# Access Compliance Report

## Public Rights-of-Way

Intersection ID: 8758	Main Street: COVECREEK_DR	Cross Street: EASTBROOK_RD	Location:	SW
ADA ID: 1215DD358025	Ramp Type: BlendTrans1	Initial Pass/Fail: Pass	Overall Compliance: No	Severity Score: 5
Codes/Mitigation Info/Possible Solution		Field Measurements/Component Compliance

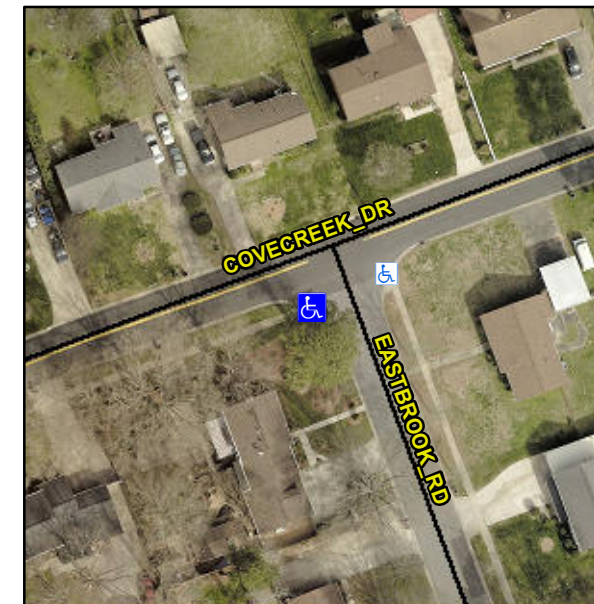
**Not Found, R304.2.2-Perp, R304.3.2-Para, R304.5.3, R305.2, R304.5.4**

Compliance	Description	Data	Compliance	Description	Data
N/A	Ramp Length (in)	56.5	Yes	BlendTrans Slope (%)	1.6
Yes	Ramp Width (in)	48.0	Yes	BlendTrans XSlope (%)	0.5
N/A	Flare Type LT	Sloped	N/A	Flare Type RT	Sloped
N/A	Flare Slope LT (%)	0.3	N/A	Flare Slope RT (%)	1.8
N/A	Flare Traversable LT?	No	N/A	Flare Traversable RT?	No
Yes	Landing Length (in)	57.0	Yes	DWS Provided?	Yes
Yes	Landing Width (in)	48.0	Yes	DWS Contrast?	Yes
No	Landing Slope (%)	2.2	Yes	DWS Length (in)	24.0
No	Landing X Slope (%)	2.6	Yes	DWS Full Width?	Yes
N/A	Landing Curb? (Y/N)	No	No	DWS Offset (in)	4.5
N/A	Shared Landing?	No			
Yes	Gutter Ponding?	No	No	Gutter Slope (%)	5.7
Yes	Gutter Lip Ht (in)	0.0	Yes	Gutter X Slope (%)	1.5
N/A	Painted X Walk1?	No	N/A	Painted X Walk2?	N/A
	X Walk 1 Direction	To E		X Walk 2 Direction	N/A
	X Walk 1 Width (in)	N/A		X Walk 2 Width (in)	N/A
	X Walk 1 Slope (%)	2.3		X Walk 2 Slope (%)	N/A
	X Walk 1 X Slope (%)	0.7		X Walk 2 X Slope (%)	N/A

N/A	Ramp inside XWalk1?	N/A	N/A	Ramp inside XWalk2?	N/A
	Road Slope (%)	0.7		Clear Space?	Yes
	Road X Slope (%)	2.3	N/A	Clear Space to XWalk (in)	N/A
Yes	Any Obstructions?	No	Yes	Storm Grate/Utility Hazard?	No
	Obstruction Type			Storm Grate/Utility Type	
		N/A			N/A
			Yes	Surface Condition? (G/P)	Good
			No	Curb Slope (%)	16.6

**Remove & Replace Curb Ramp With Two New Directional Ramps or Equivalent. Remove & Replace Gutter.**
